SUBJECT: **ELECTRIC CAR PROJECT MEETING**  
**Tuesday, June 28 at 8:00 a.m. at ACC**

**TO** Howard Wilson  
**FROM** Alec Brooks, Paul MacCready  
**DATE** June 27, 1988  
**SUBJECT** Electric Vehicle Design Approach  
**COPIES TO** Peter Lissaman

**TO** John Schinella, Don Macfarlane, Jon Albert, Rick Drumsta  
**FROM** Alec Brooks  
**DATE** Feb. 22, 1989  
**SUBJECT** Under-hood packaging and glass weight  
**COPIES TO** Howard Wilson, Jerry Williams

Glass Weight Status

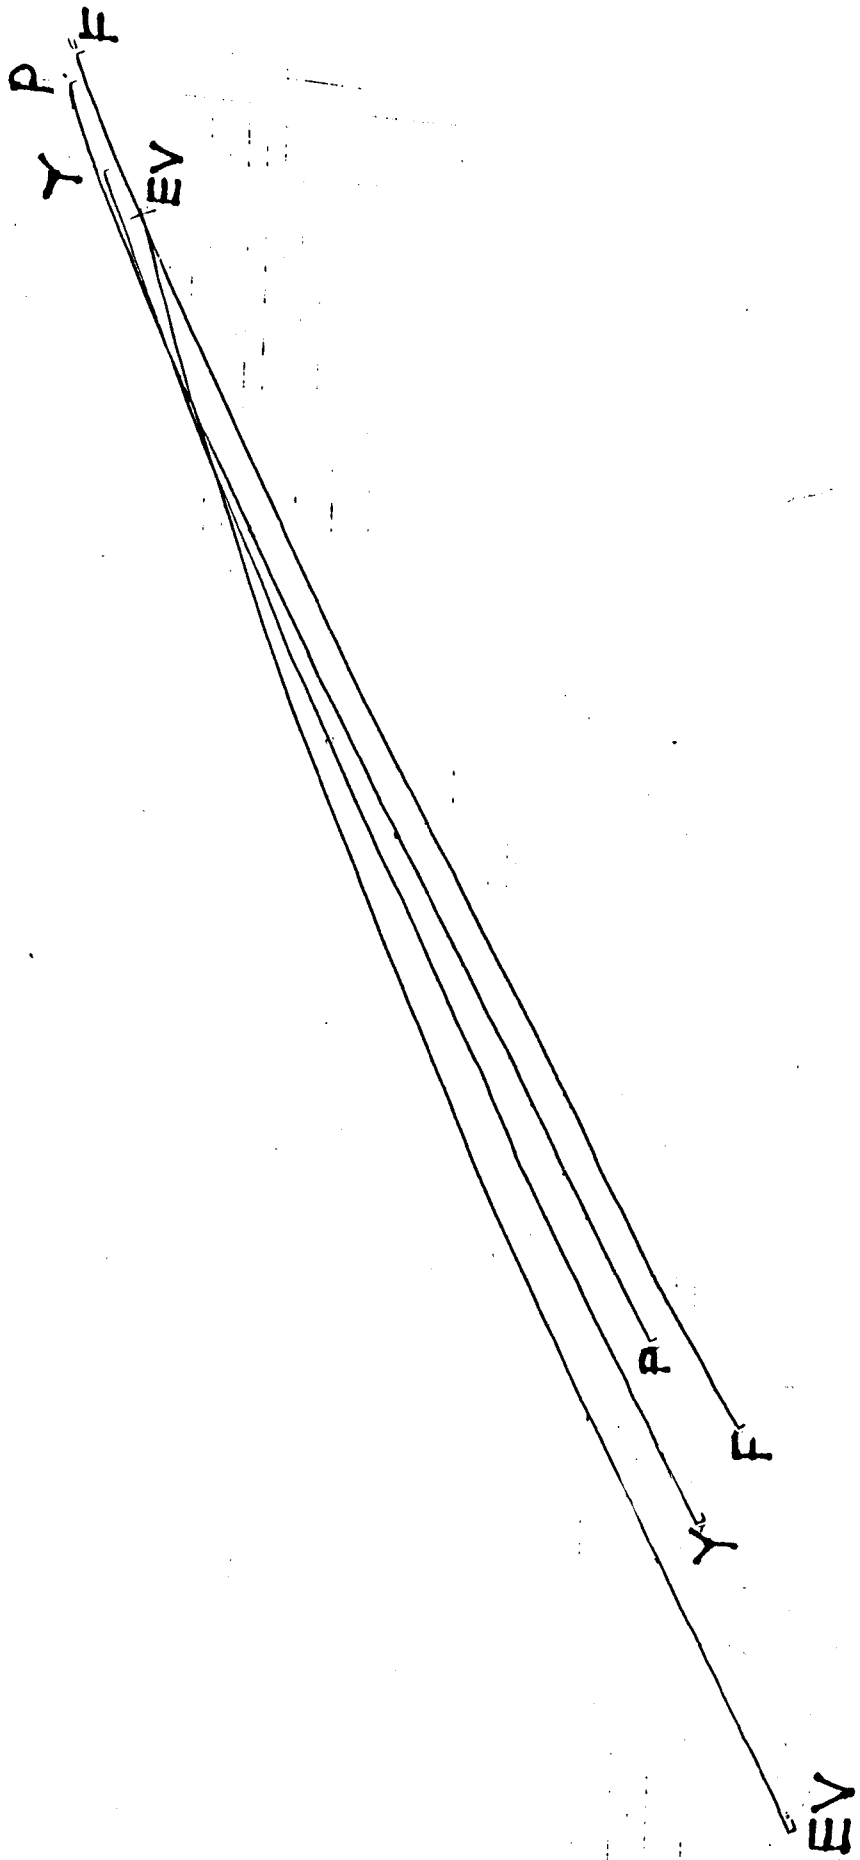
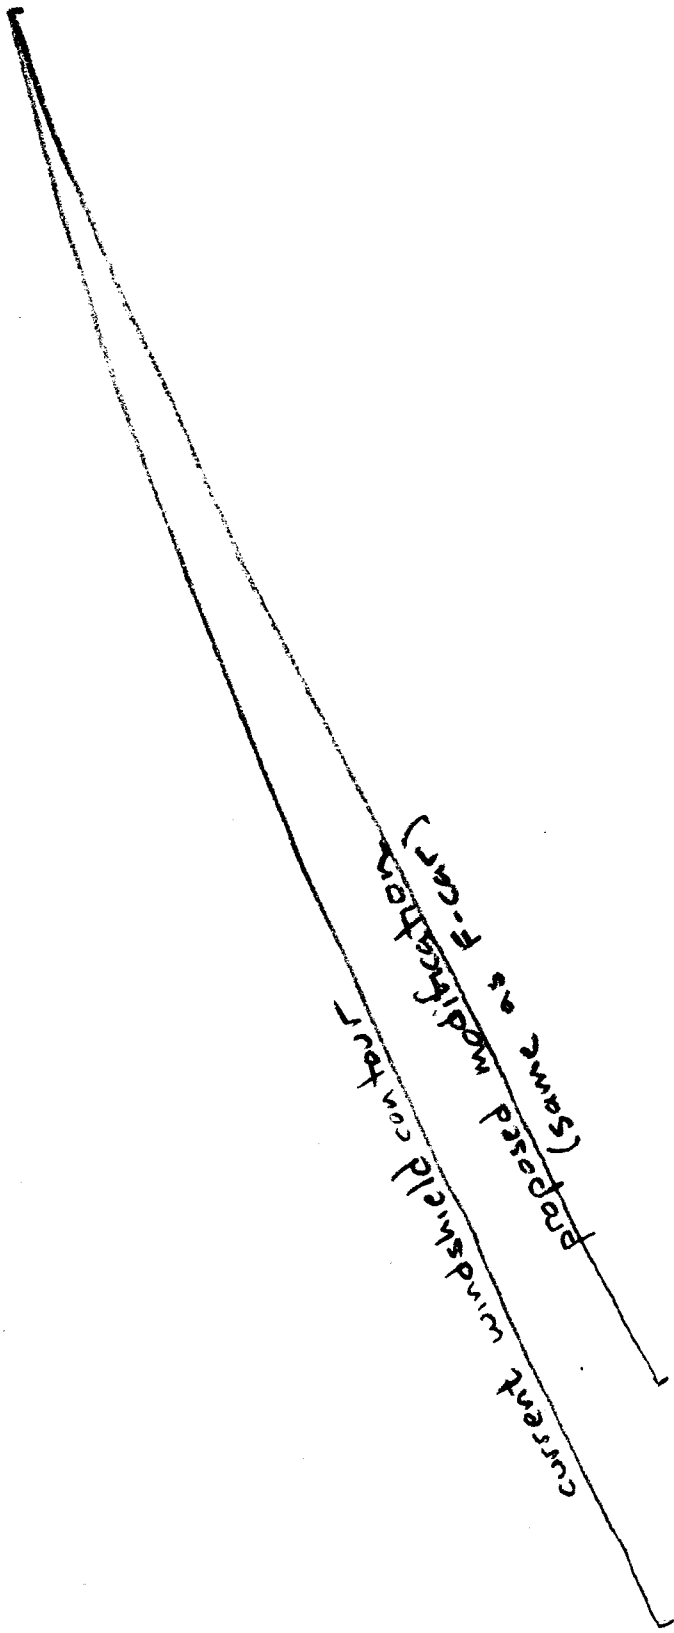
In the sheet that I faxed out on Monday, I outlined where we stand on glass weight (A copy is attached). As you can see, we are 11.9 pounds, or 27 percent over the target for all of the glass. Almost all of the overrun is accounted for by the windshield. In order to understand why the windshield weight is high, we have put together (with the help of AES) a drawing comparing the centerline windshield contours for the current EV design with those for the F, Y, and P cars. All windshield locations are shown relative to a common H-point. A reduced copy of the drawing is attached. Although the angles at the windshield bases are all about the same, the EV windshield is substantially larger than the others due to its curvature. Specifically, it is 15 percent larger than the F-car, 26 percent larger than the P-car, and 19 percent larger than the Y-car.

Mod. suggested by ANB Feb 22

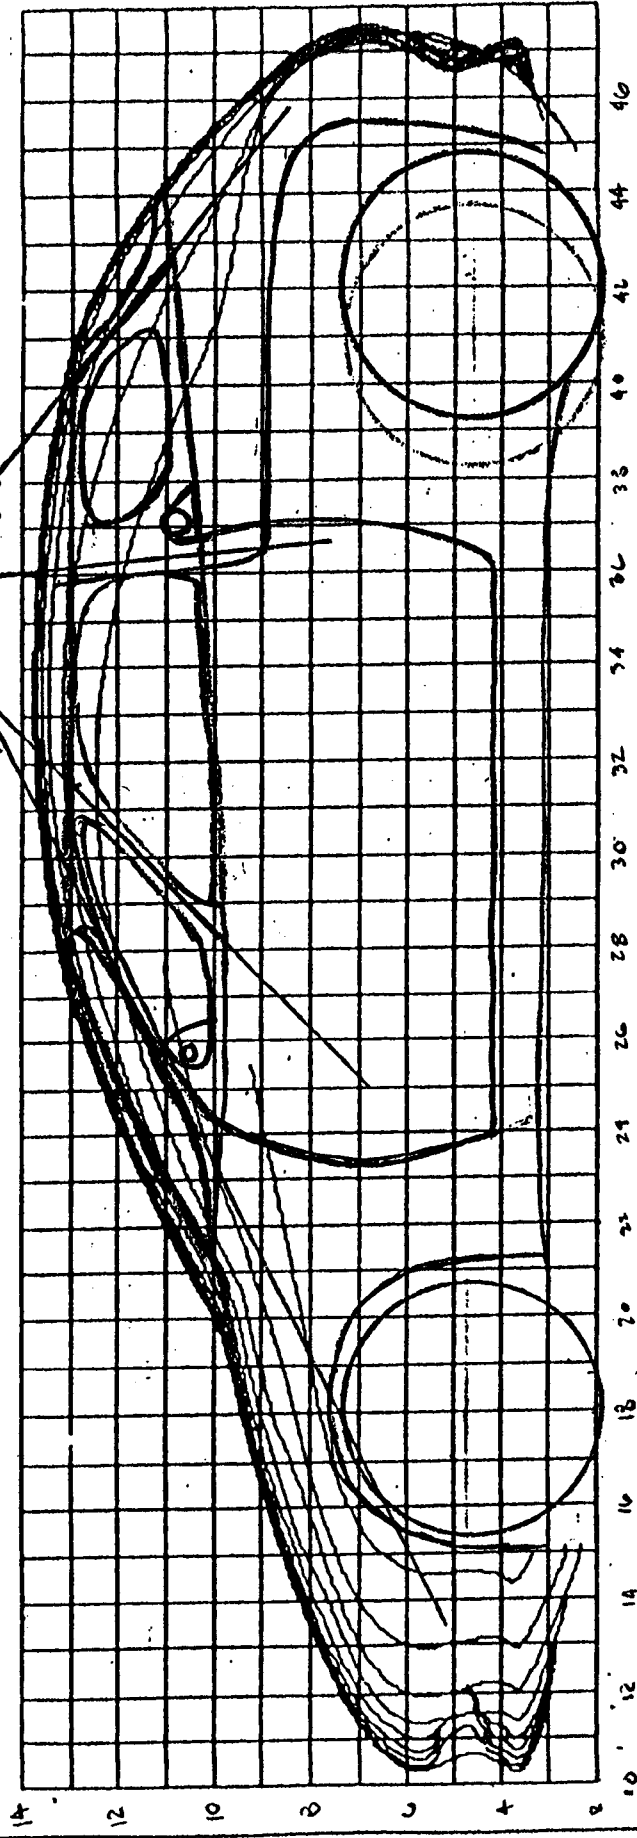
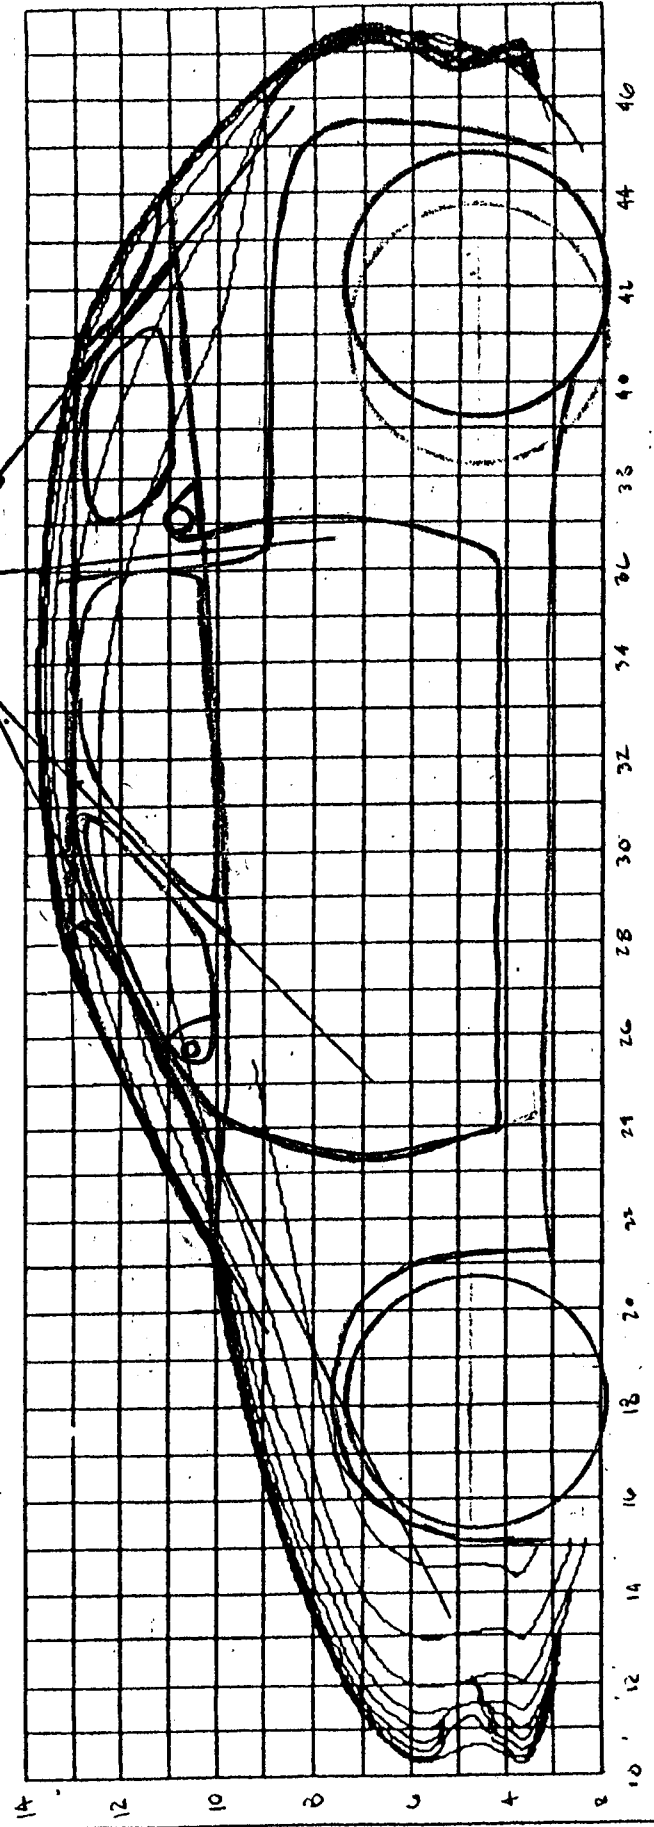
In view of the aforementioned concerns, I would like to suggest that you seriously consider the following modification to the vehicle design: move the base of the windshield 5 inches rearward, while leaving the header in the same location. This will result in a windshield cross sectional contour nearly identical to that of the F-car, as shown on the attached drawing. Assuming PPG provides the thinner two-ply glass for the windshield, this change would bring the overall glass weight down to 46.1 pounds, or only 3 pounds above the target. The additional room under the hood would allow considerably greater freedom in packaging and component selection, leading to a lighter and more efficient powertrain installation. This change would result in a minor slope discontinuity where the windshield meets the roof (similar to most cars), but would most likely have no effect on the drag.

By now you should have received a copy of Don Macfarlane's response to my memo of Feb. 22. A copy is attached in case you haven't. I have also attached current drawings showing the baseline car and the car with the modified windshield which is "not aesthetically acceptable".

As shown in the attached drawings, the windows have been reduced in size by rounding all of the edges. The new glass weight estimate is 51.9 pounds with the standard PPG glass, or 46.4 pounds with the thinnest PPG glass. The glass weight target is 43.4 pounds. The windshield change that I had requested would have brought the weight down to 46.1 pounds.

Thank you for your suggestion concerning moving the base of the windshield rearward for glass weight reduction and underhood packaging considerations. We have made a layout of the proposed windshield centerline and compared it to what is currently on the clay model. The resulting shape change is not aesthetically acceptable.

We do share your concern about vehicle weight, though, and realize the contribution the glass is making to the overage. With this in mind, we are reviewing the size of glass panels and their related openings as the full size design progresses. Weight is being reduced as glass overlap of metal around openings is minimized and glass is eliminated from areas where it is not required for visibility. We will keep you informed on our progress in this area.
